Planning Commission Hearing Staff Report

**Apollo Burger Drive Through Restaurant**  
Conditional Use Review PLNPCM2010-00516  
Building and Site Design Review PLNPCM2010-00488  
Located at approximately 143 North Redwood Road  
Hearing date: October 27, 2010

**SP 101**  
SHEET 3 OF 8

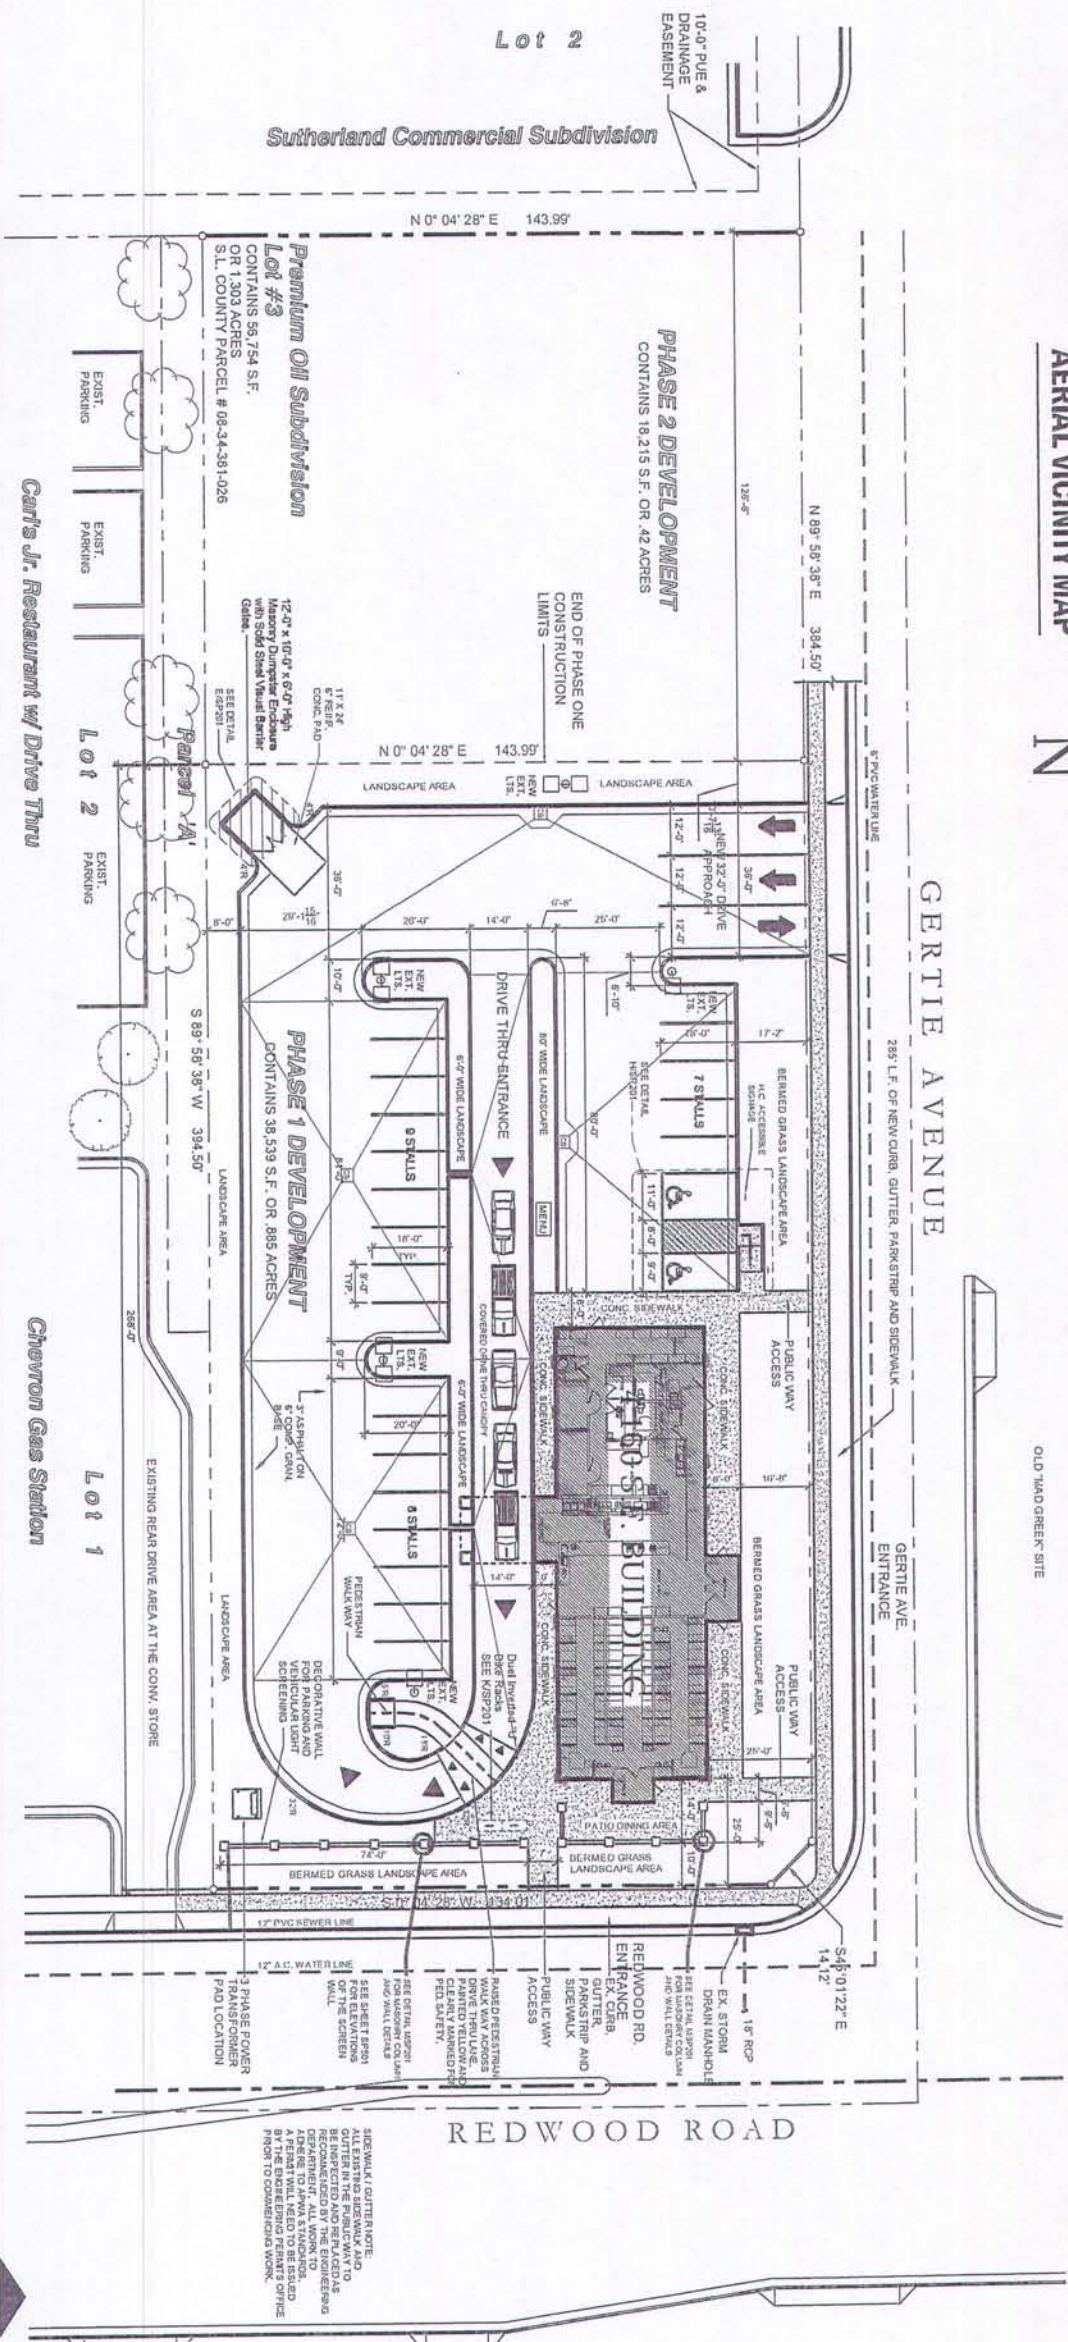
The proposed restaurant is adjacent to Redwood Road and Gertie Street (145 North). The front façade faces Redwood Road as does the primary entrance (vestibule) of the building. The new proposal includes an outdoor dining patio on the east side and a decorative two-foot high fence that will serve as a buffer from the outdoor dining patio and the sidewalk. The newly proposed single drive-through lane and pick up window are located on the south side of the building facing 17 parking stalls. The two-foot fence will also extend along Redwood Road providing parking and vehicular light screening. There are additional entrances to the building, one vestibule facing Gertie Avenue, a door on the south façade next to the drive up window and another door on the Redwood Road façade adjacently to the primary vestibule. (See Attachment A: page SP101 of the drawings)

The new revised site plan relocated the driveway and drive up window at the south of the building and directing circulation to the south and interior of the lot. The site plan also proposes to move the building closer to the sidewalk while meeting the 15 foot front and corner sideyard requirements while adding an outdoor patio adjacently to the front façade between the sidewalk and the building. Parking is provided in the back of the building (to the west) as well as to the south façade.

Mr. Barry Walsh from the Division of Transportation reviewed the newly submitted site plan and turned comments stating that the proposed drive on Gertie Avenue needs to be designated with one entry lane, and one

right turn and one left turn exit lanes. Moreover, the landscape needs to comply with the 10x10 Clear sight zone height restriction of 30 inches (the Mugo pine is not acceptable). And finally, that public way improvements are required along the full lot frontage (385') of Gertie Street.

**Analysis:** The modified site plan will have a driveway and a drive up window located adjacently to the south facade of the building and an interior parking lot in both the rear and south sides of the building. Although there are no anticipated impacts on adjacent properties from motorized or non-motorized traffic, the internal circulation of pedestrian traffic has been improved but it will still be compromised by the driveway at least once in the south façade of the building.

**Analysis:** The proposed drive through restaurant is auto oriented in nature, even though the driveway has been relocated to the south side of the building. This still presents conflict points between

**Analysis:** The revised proposal will have a parking lot on the back and south side of the building. It will have a total of 24 parking stalls, which are concentrated in groups of 7, 8 and 9 stalls interrupted by landscaping and new trees. Currently there are no mature vegetation in the lot. The applicant proposes to add other vegetation within the landscaped areas in the perimeter of the lot. The proposal also includes a walkway by the building on the rear, south side and front façade, however, the width varies and is not 10' wide consistently. The front walkway from the south parking lot that connects to the entrance is raised and 7' wide. As stated previously, all surrounding land uses are commercial in nature.

**Analysis:** The revised development proposes to add 3 pedestrian connections from the sidewalks adjacent to the public streets. The connections will be vary from 5' to 7' wide and are not directly oriented to either entrance to the building. The site plan shows a 7'e path from the parking lot to the Redwood Road entrance. Despite the fact that efforts have been made to relocate the drive through lane, pedestrian internal circulation and auto conflict points still remain, though reduced from previous site plan.

1. The proposed development is subject to compliance with all applicable Department Comments and City regulations.
2. Applicant shall install and maintain a sufficient layer of organic mulch within all plant beds to reduce heat and improve plant nutrition.
3. Where possible, additional accent lighting of architectural and landscape features is encouraged.
4. Property owner shall post a sign informing their patrons to shut off their car while waiting for service.
5. All doors shown in elevation drawings and floor plan drawings shall be reflected into site plan when requesting a building permit.
